#### **BID ADDENDUM NO. 03**

PROJECT: Pine Bush Central School District

2019 Capital Improvement Project – Phase II

CPL PROJECT NO: 14533.05

Pakanasink Elementary School: Overhead Coiling Doors Photo (Typical of 3).

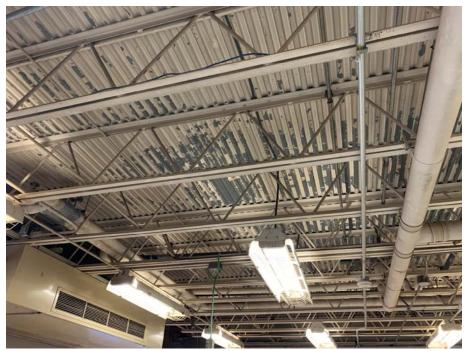
- A. Door Schedule and Detail 1/A900:
  - a. Doors 1-002, 2-002 and 3-002:
    - i. Revise size to 9'-0" wide x 9'-4" high (Door Type E).
    - ii. New doors shall be insulated coiling door with associated hood.
    - iii. Current masonry opening is 9'-0" x 8'-0" and shall be increased in height by 16" by removing two courses of cmu masonry and affiliated brick façade. Provide new steel (HSS 8x6x5/16) at existing CMU opening. New steel angle to support brick.
    - iv. New steel angles shall be replaced at jamb and head of each door.
    - v. See attached photos for reference.

PAKANASINK ELEMENTARY SCHOOL WINDOW DETAILS, TYPES & SCHEDULE

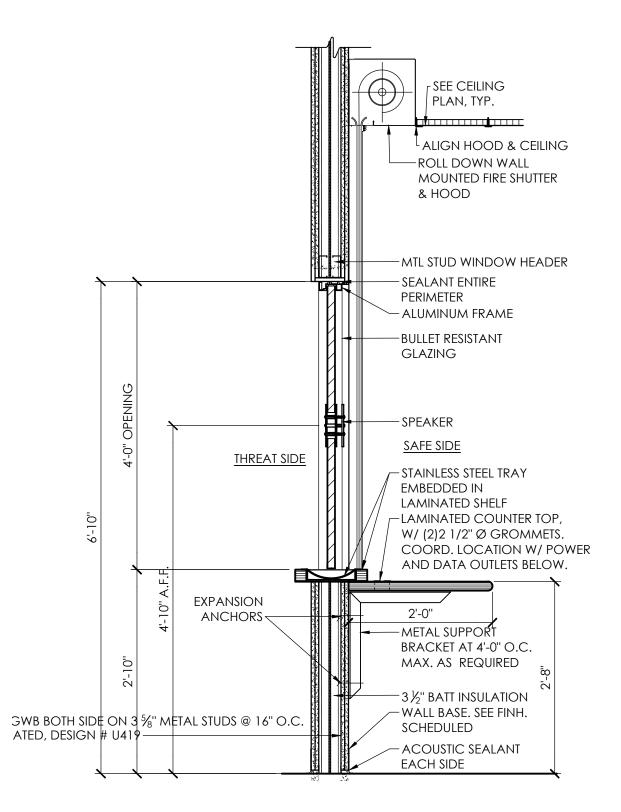
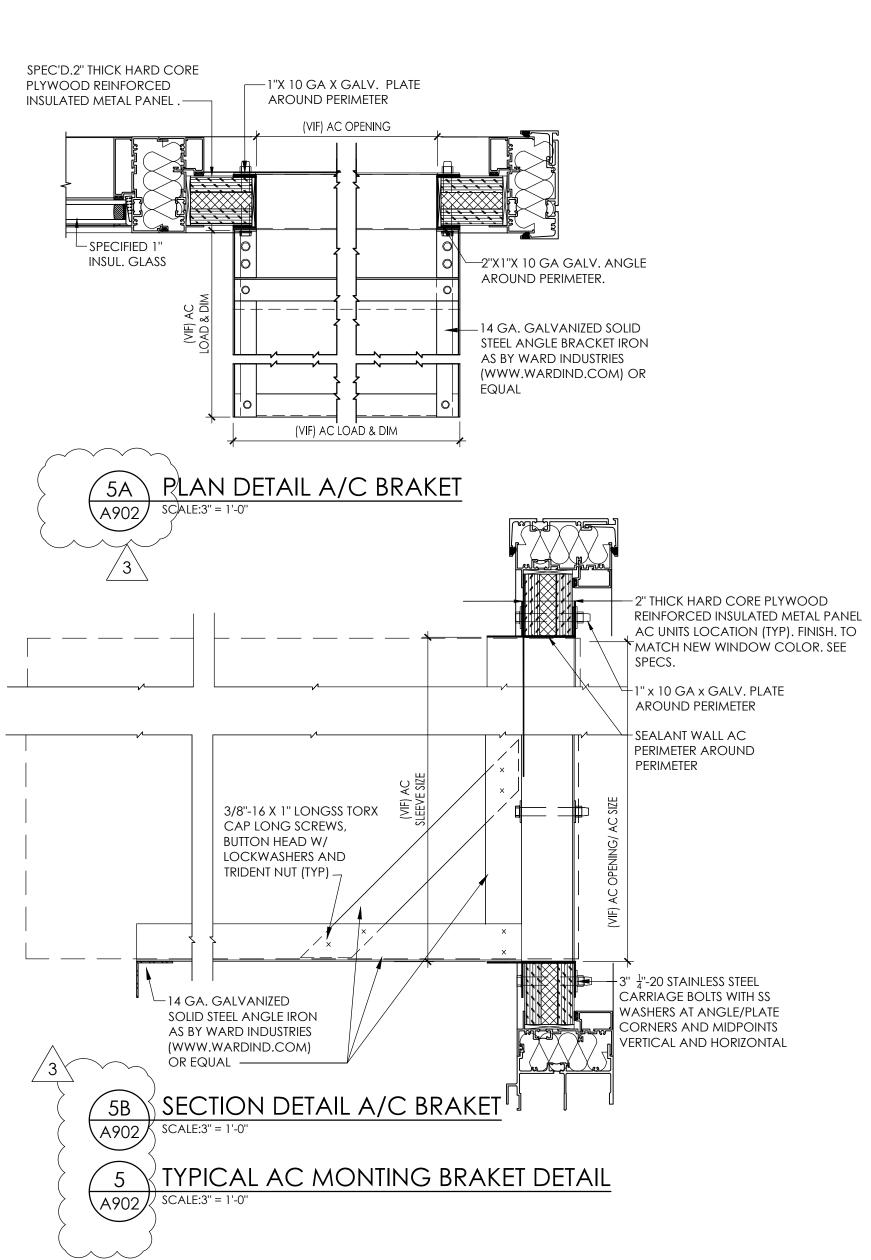
- A. Replace with drawing attached to this addendum.
- B. Window Type W3
  - a. Provide two fixed lites above slider.
